ACCESS REPORT
DEVELOPMENT APPLICATION

35 WILFRED BARRETT DRIVE
ENTRANCE NORTH

MULTI-UNIT RESIDENTIAL DEVELOPMENT

7TH April 2011
(Amended 26th June 2012)

Accessibility of Common Domain Areas

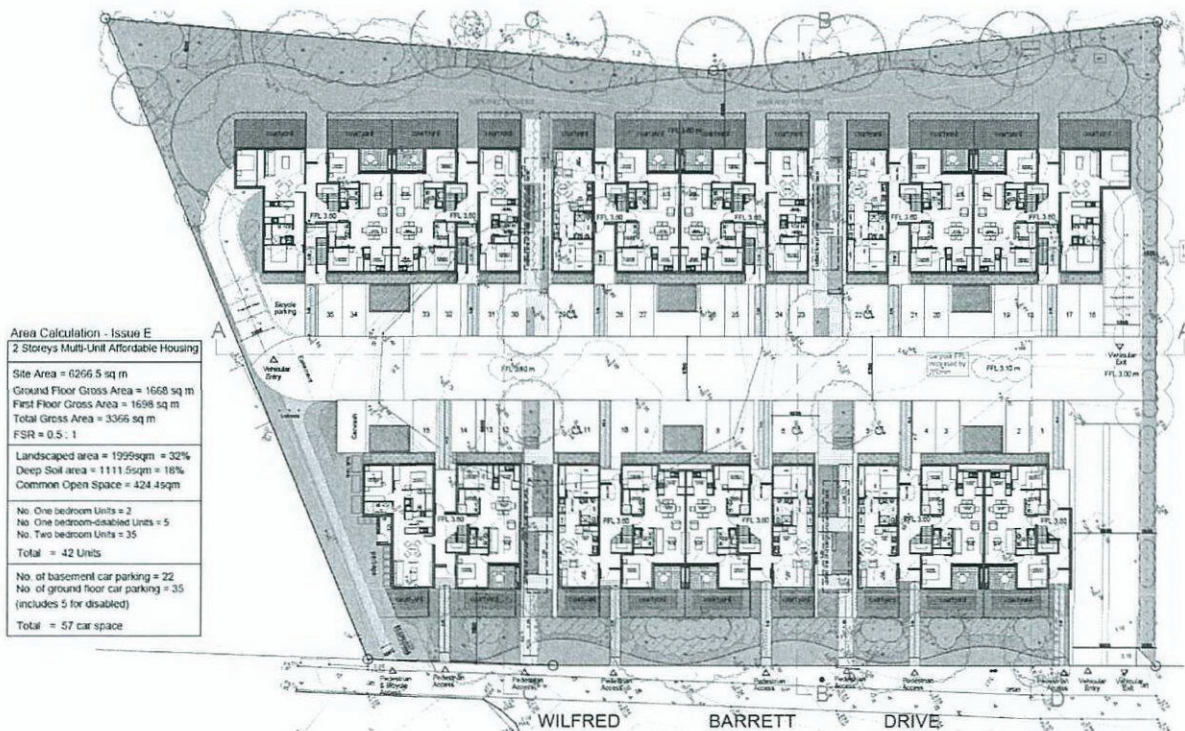
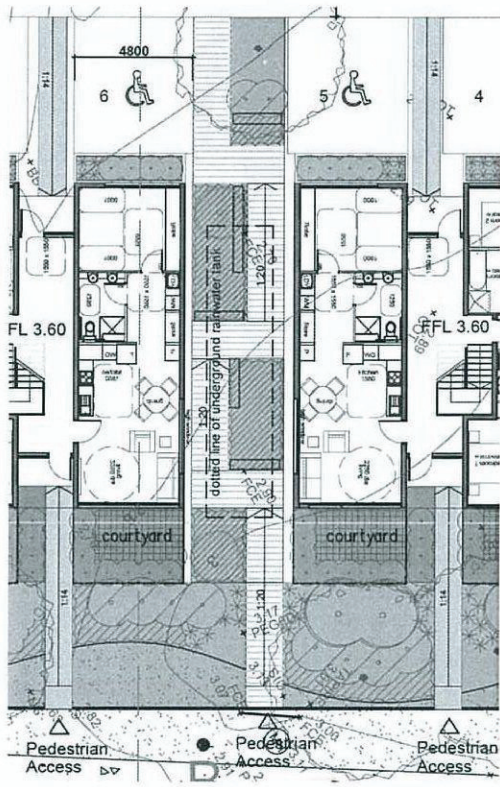
Clause	Accessibility Assessment – Common Domain	Compliance
BCA Table D3.1	<p>Site Access Paths -</p> <p>The plans show an entrance that provides on-grade access with 1:20 gradient walkways, 1:14 gradient ramp and 1:10 step ramp access from the public domain footpath to the front entry door of all twenty-one (21) ground floor units to satisfy Table D3.1 of the BCA.</p> <p>Details of ramp handrails and tactile indicators shall be confirmed at construction certificate stage in accordance with ASI428.1 and ASI428.4.1.</p> <p>The Common Landscaped areas between the buildings propose on-grade transition access from the paved ramp landings which enables satisfactory access to this soft landscaped area and communal facility.</p>	YES
		YES
BCA D3.3(a)(ii) D3.8	<p>Stairways</p> <p>In accordance with part D3.3(a)(ii) of the BCA the stairways will be detailed at construction certificate stage with handrails on both sides to the requirements of ASI428.1, step nosings, closed risers and tactile ground surface indicators.</p>	YES

BCA Table D3.1	<p>Letterboxes</p> <p>The letter boxes shall be adjacent the site entrance driveway and will provide at least 1550mm X 1550mm circulation area and access to comply with ASI428.1 to satisfy Table D3.1 of the BCA.</p>	YES

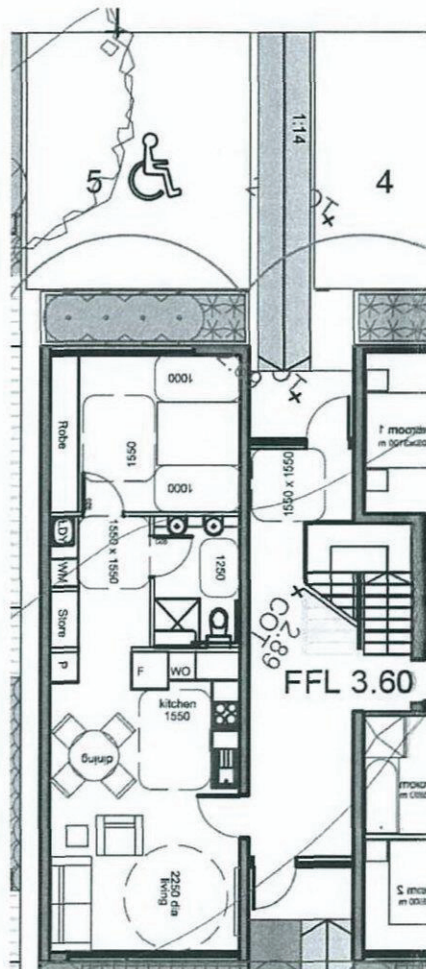
AS4299 Clause 4.7	<p>Living and Dining rooms – The plans show combined living and dining areas on a single level with sufficient area to provide a 2250mm diameter turning area to comply with this clause.</p>	YES
AS4299 Clause 4.5	<p>Kitchen – with regard to kitchen design the L-shaped kitchen inherently provides 1550mm clearance between benches to comply with AS4299.</p> <p>With regard to the “adaptability” of the kitchen the construction drawings shall provide details of an appropriate layout of sink, fridge, wall oven, cooktop and height adjustable workbench that readily satisfies the “ease of adaptation” guidelines outlined in section 2 –</p>	YES YES

Clause	Adaptability Assessment	Compliance
	Performance Objectives of AS4299. Therefore, subject to confirmation of the installation of kitchen cupboards, appliances and the like at the construction documentation stage it is evident that the kitchens will comply with AS4299.	
AS4299 Clause 4.6	Main bedroom – The plans show a main bedroom for the adaptable units that are at least 3500mm X 3600m which allows a circulation area of 1540mm X 2070mm clear of a queen sized bed and in front of the wardrobe while maintaining 1000mm clearance on both sides of the bed to satisfy AS4299.	YES
AS4299 Clause 4.7	Bathroom – The plans show that the bathroom will be at least 2000mm X 3000mm which enables compliance with AS1428 in terms of spatial area. To facilitate adaptation to an accessible unit the toilet pan, washbasin and shower are in pre and post adaptation to satisfy the performance requirements of AS4299.	YES

AS4299 Cls 4.4.3	Toilet – The toilet within the bathroom shall comply with AS4299 by providing 1250mm X 900mm in front of the WC pan.	YES
AS4299 Clause 4.8	Laundry – The laundry facilities are provided in a closet, which enables 1550mm X 1550mm clear circulation space in front of the appliances to comply with AS4299.	YES
AS4299 Cls 3.5(b)	Outdoor Private Open Space – The plans show outdoor terrace area adjacent living area with sliding doors. The areas provide adequate space to perform a 180 degree wheelchair manoeuvre. While the plans do not indicate thresholds the construction drawings will confirm a 35mm maximum change in level with the capability for threshold ramps to comply with AS1428/4299.	YES
